EVMK2HX Known Issues

3. EVMK2HX Rev 1.1 Hardware Modifications

Rev 1.1 EVM keeps the schematics and PCB layout same as Rev 1.0 EVM, but following BOM change and reworks are made in Rev 1.1 EVMs for better stability.

2.2 VCC0V85 Voltage Drop Issue

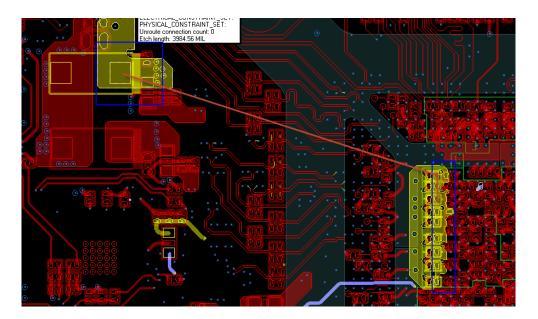
- <u>Description</u>: The trace width of the VCC085 signal is too narrow and causes a voltage drop at the pin of the SOC. Since this supply is used for SerDes interfaces it could cause SerDes interfaces to lose link. This issue has only been identified and observed on the SGMII.
- <u>Workaround</u>: A couple different options are still under investigation for their effectiveness.
 - 1. Add external wire to provided adequate patch for expected current from pin 1 of "C503" (net VCC0V85) to pin 1 of "C564, C574" (net VDD0V85). (Wire length = 5 cm)

Note: That the rework should not link to GND and cause short circuit.

Plans for a fix: The trace width will be fixed on Rev2.0. The filter element on AVDDALV requires an increased current capacity (suggest up to 4A) to allow for margin on worse-case power as per latest Snowbush power estimates when all SERDES are active. Increase of current capacity on filtering elements for AVDDAHV also recommended (suggest up to 3A). Please see latest estimates below. CVDD power budgeted already on the DSP AVS supply. Both of these nets shall be implemented as copper pours up to the filters and as a plane afterwards to minimize resistance and inductance and maximize plane capacitance.

<u>Workaround</u>: An external wire is added to provided adequate patch for expected current from pin 1 of "C503" (net VCC0V85) to pin 1 "C564, C574" (net VDD0V85). (Wire length = 5 cm). Also, the wire is glued on heat sink back plate for stability.

2.3 I2C SDA/SCL Reserve Issue

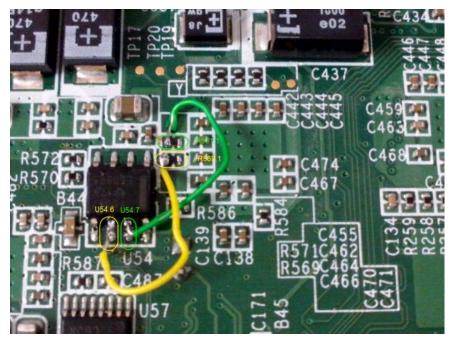
- <u>Description</u>: SCL and SDA are swapped on U54 bus repeater. Impacts I2C going to 120p Expansion Connector and Zone 3 RTM connector.
- <u>Workaround</u>: Cut the jumper wire (30AWG) to swapped signal of EXP_SDA2_3V3 and EXP_SCL2_3V3. Two wire each to similar yellow and green to link from U54.6 to R569.1 and U54.7 to R571.1.

<u>Plans for a fix</u>: This will be corrected on Rev2.0.

Workaround: External rework wires (30AWG) are added to swapped signal of EXP_SDA2_3V3 and EXP_SCL2_3V3.
